Global Change Notification (GCN)

Product Family Field attachable Din 10628034

Series 121119 March 12, 2014

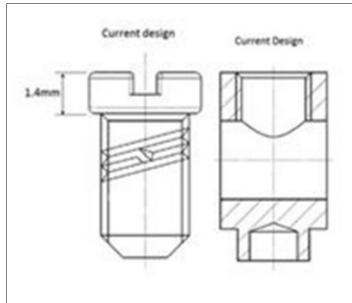
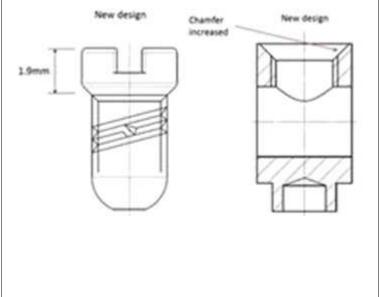
We are introducing a change to the screw used in the field attachable din connector. The head of the screw is being made more robust allowing the depth of the slot to be increased. The reason behind this change is to make the head of the screw more robust based on some market feedback from some specific areas that require this improvement. The improvement will be beneficial to all our customers and applications world wide.
